Energy Harbor Nuclear Corp.  
Perry Nuclear Power Plant  
10 Center Road  
P.O. Box 97  
Perry, Ohio 44081

July 14, 2022  
L-22-171

Subject:  
Perry Nuclear Power Plant  
Docket No. 50-440, License No. NPF-58  
Response to Request for Additional Information Regarding Proposed Inservice  
Inspection Alternative IR-063 (EPID L-2022-LLR-0005)

Figure RAI-NVIB-02-A-1: Unit Internal Pressure, Paths P1 and P2

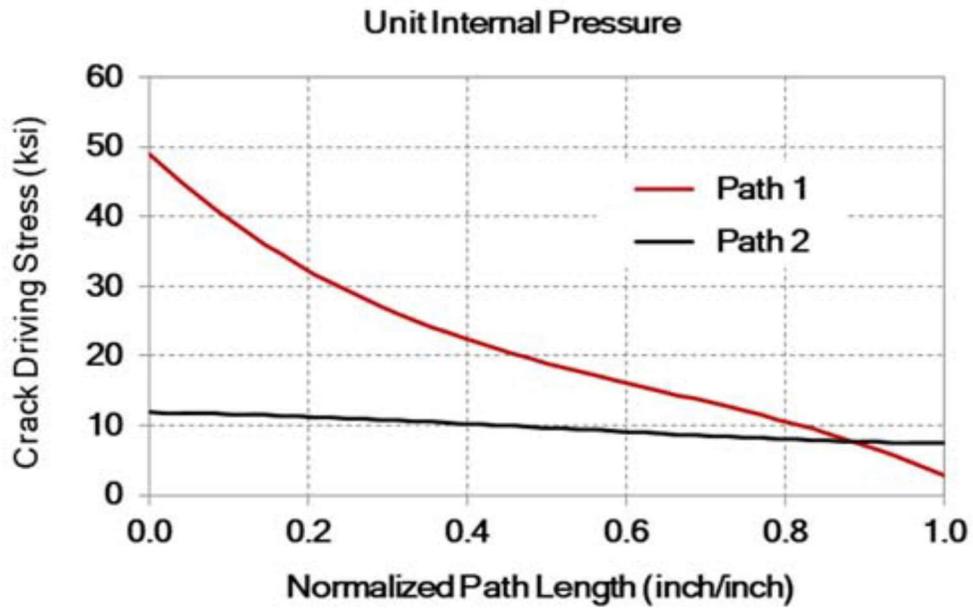
- (a) similarities and differences between the assumed stress types (i.e., hoop or axial) for stress paths P1 and P2 being applied to the PNPP RFW nozzle inside radius sections, as analyzed using the reiterative VIPERNOZ Monte Carlo runs for random generated inside radius semi-elliptical flaws in the radius sections;**

Under internal pressure load, the stress distribution of P1 is higher as compared to P2, as displayed in Figure RAI-NVIB-02-A-1.

Figure RAI-NVIB-02-C-1: Unit Internal Pressure, Paths P3 and P4

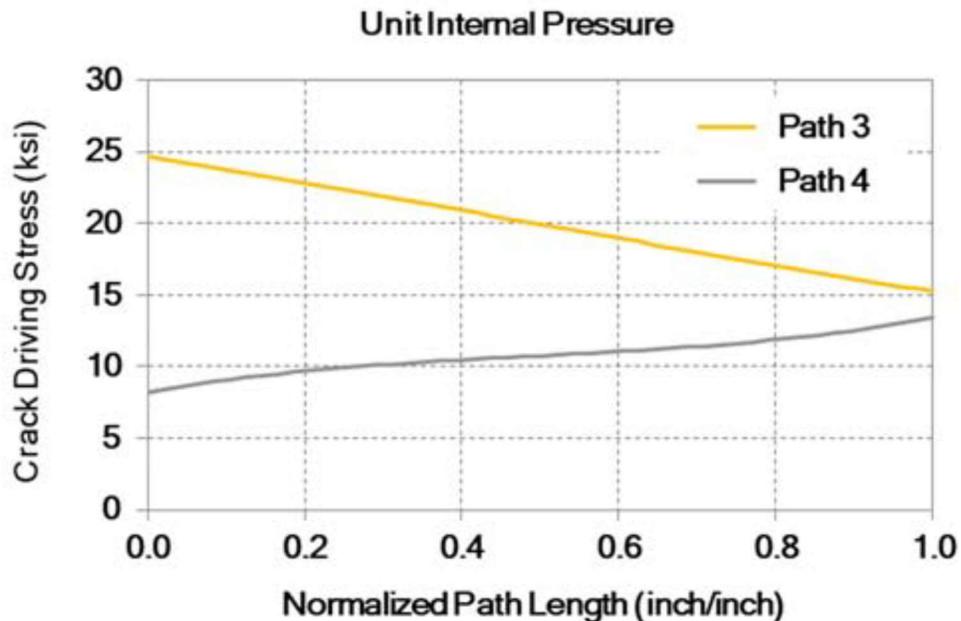
- (c) the similarities and differences between the assumed stress type (i.e., hoop or axial stress) being applied to the VIPERNOZ Monte Carlo runs for PNPP RFW nozzle-to-vessel weld semi-elliptical axial flaws and semi-elliptical circumferential flaws (under the applicable stress path, P3 or P4, for the specified flaw type, including all applicable stress inputs).

Under internal pressure load, the stress distribution of P3 is higher as compared to P4, as displayed in Figure RAI-NVIB-02-C-1.

Figure RAI-NVIB-05-1. Pressurizer Surge Nozzle Inside Surface Stress Plots due to WOL Repair

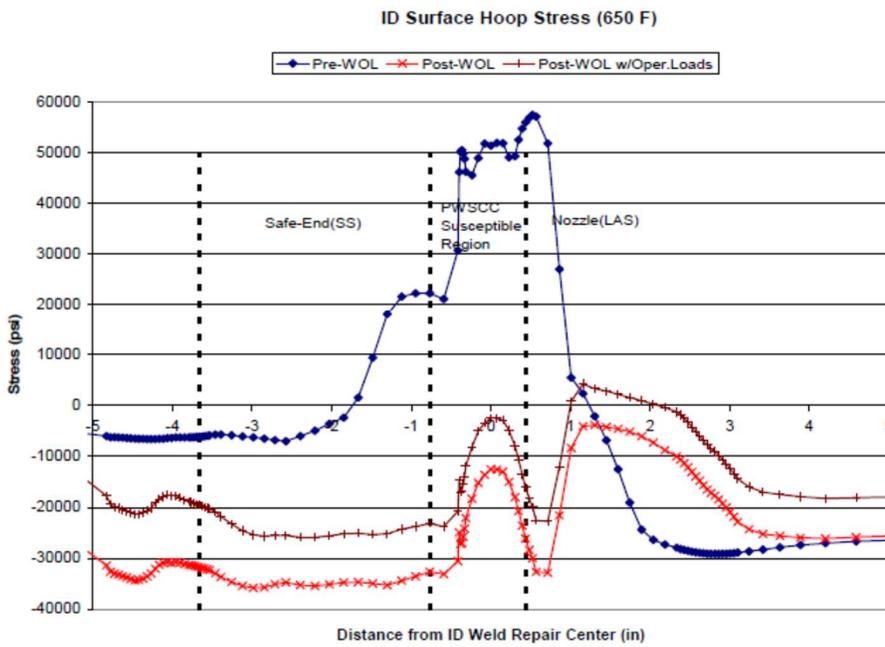
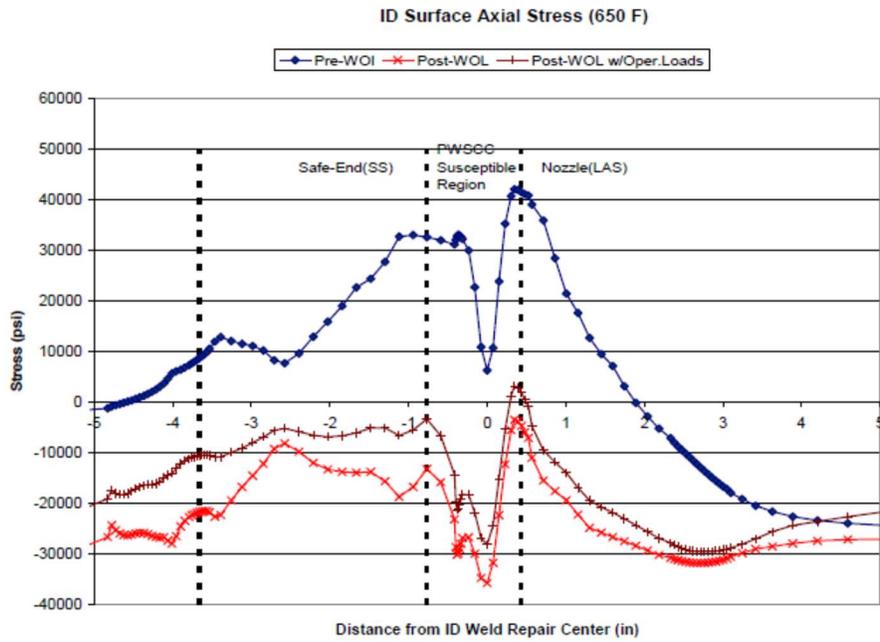
- (b) If EHNC has implemented weld repairs in any of the RFW nozzle-to-vessel welds (or nozzle-to-safe end welds) since initial operation of the unit, clarify how stresses introduced by the repair welds were accounted for in the FEM stress analyses for the assessed RFW nozzle-to-vessel weld components (including treatment of any weld residual stresses that may have been introduced into the nozzles as a result of repair welding melt and solidification processes).**

Figure RAI-NVIB-05-1, included in this response, is reproduced from MRP-169, Revision 1, Figure 8-12. A review of Figure RAI-NVIB-05-1 shows that at 5 inches from the center of ID repair (located at the nozzle-to-safe end weld):

1. The axial stress at 650°F pre- and post-WOL are compressive and within 3,000 pounds per square inch (psi). And the operating axial stress is a little over 5,000 psi between 650°F pre-WOL and the 650°/2235 pounds per square inch gauge (psig) operating condition. The majority of the operating stress increase will be due to the addition of the pressure loading. Also, note that the RFW nozzle bore blend radius begins 18.09 inches from the center of the nozzle-to-safe end weld, which is 3.618 times further away from where the result shown in Figure RAI-NVIB-05-1. In all cases, the stresses are compressive and compressive stresses decrease the R-ratio, which helps to slow crack growth.

2. Similarly, the hoop stress at 650°F pre- and post-WOL are compressive and within 1,000 psi. The operating hoop stress is a little over 8,000 psi between 650°F pre-WOL and the 650°/2235 psig operating condition. The greater difference between the hoop and the axial operating stress results is largely due to pressure given that the pressure stress will be twice as high as the axial stress. Once again, all of stress results are compressive, which reduces the R-ratio and subsequently crack growth.
